Name of project: QUICK QUACK CARWASH Date: 19 DECEMBER 2018

PLANTING PLAN  
LP101

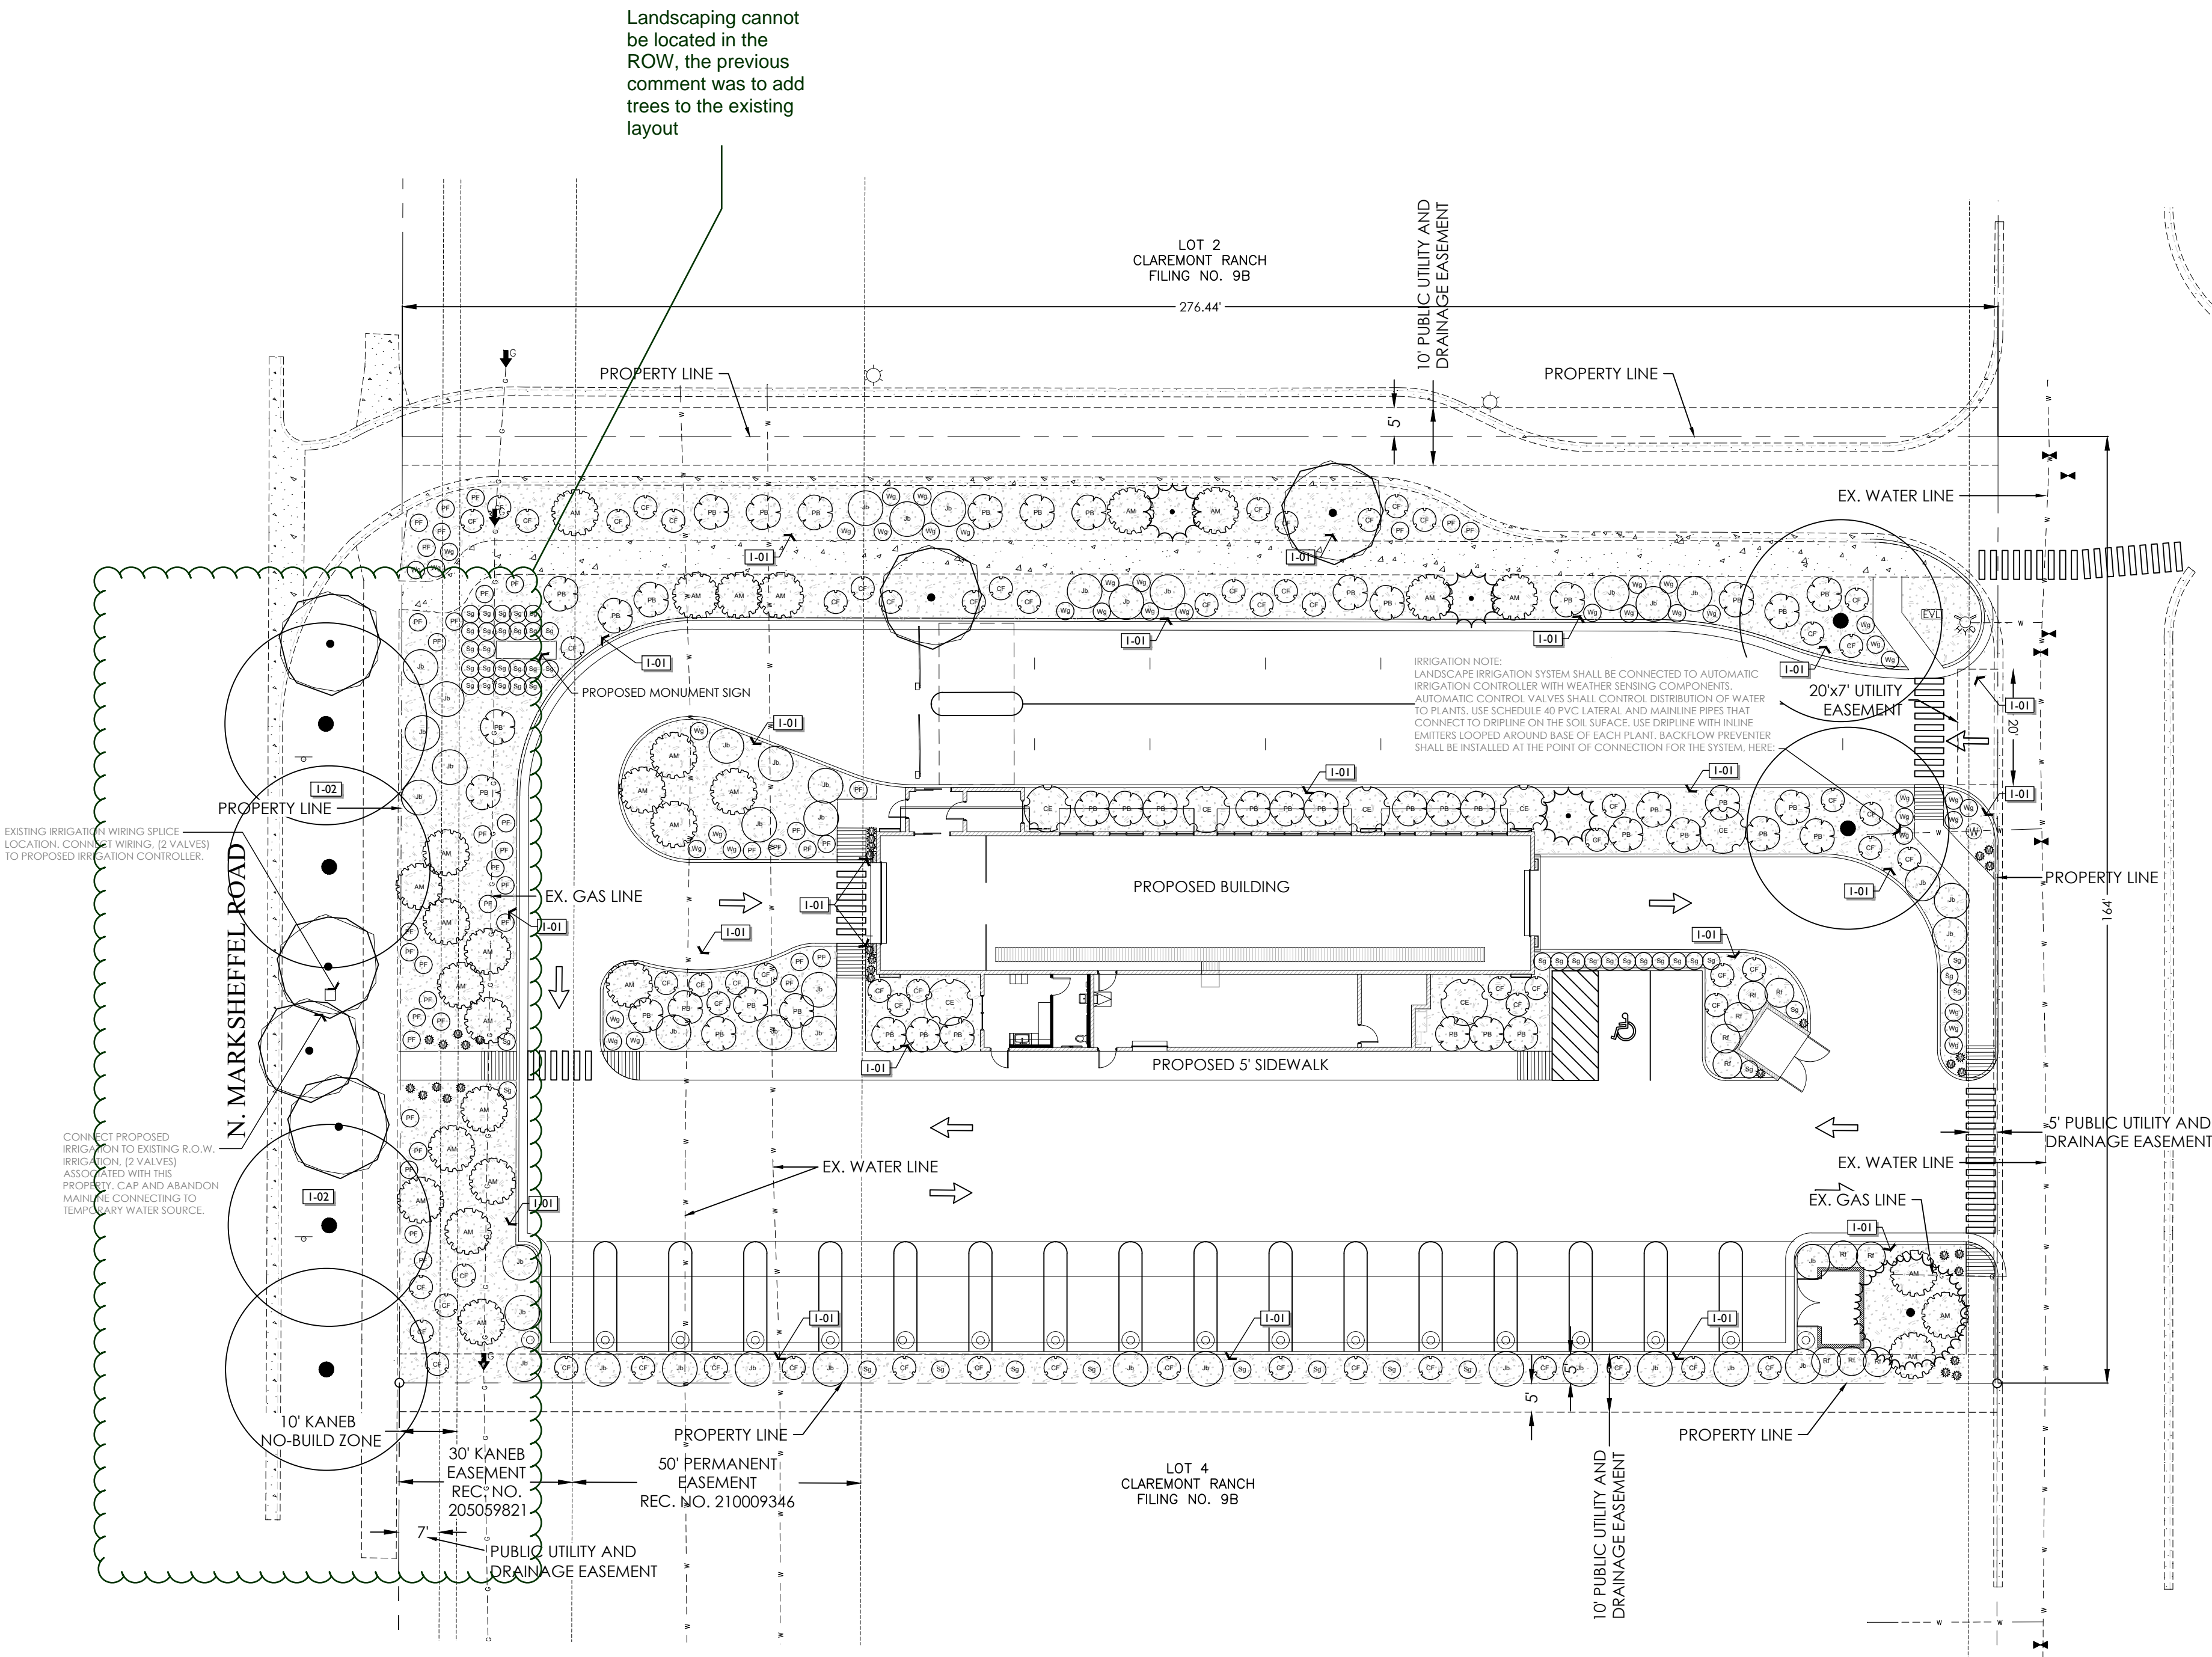
Layout subject to change with vacuum stalls  
not allowed in the water easement

<p><b>Subject:</b> Cloud+ <b>Page Label:</b> [1] QQ CoSprings Const PP-LP101 <b>Lock:</b> Locked <b>Author:</b> dsdsevigny <b>Date:</b> 4/2/2019 10:54:49 AM <b>Color:</b> ■</p>	<p>Landscaping cannot be located in the ROW, the previous comment was to add trees to the existing layout</p>
	<p><b>Subject:</b> Text Box <b>Page Label:</b> [1] QQ CoSprings Const PP-LP101 <b>Lock:</b> Locked <b>Author:</b> dsdsevigny <b>Date:</b> 4/2/2019 10:54:50 AM <b>Color:</b> ■</p>	<p>Layout subject to change with vacuum stalls not allowed in the water easement</p>
